Re: Revision for pond cleaning (13-005)

Title of Proposal: Crandall Sediment Pond Revisions (13-005)	Mine: GENWAL Mine
Permittee: GENWAL Resources, Inc.

CRANDALL CANYON MINE
 SEDIMENT POND (AS-BUILT)

REV: 11	ACAD: 7-3 R11
DATE: 06-05-13	BY: PJJ
SCALE: 1" = 40'	PLATE #: 7-3

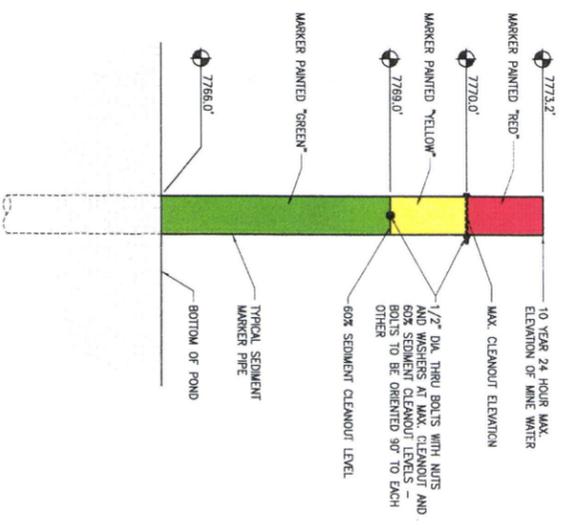
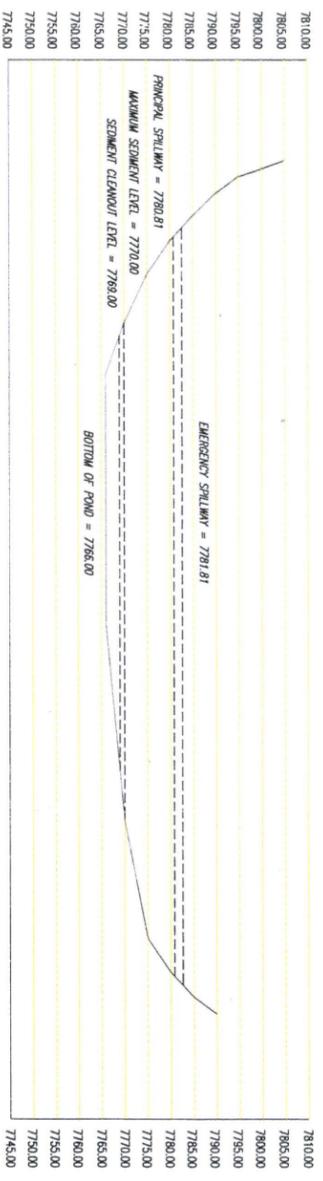
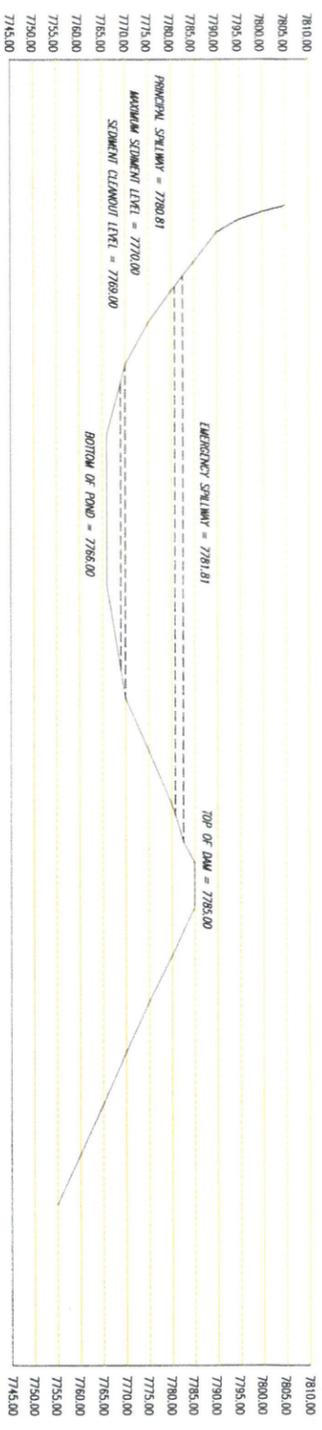
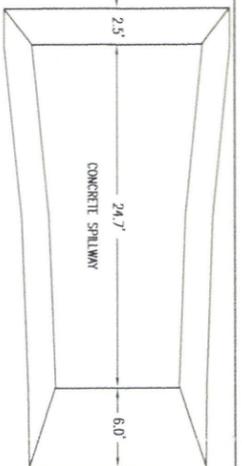
Note: Pond Cleaned in November 2003.
 Survey Made in April 2004.
 Pond Cleaned in December 2009.
 Pond Cleaned in June 2013.
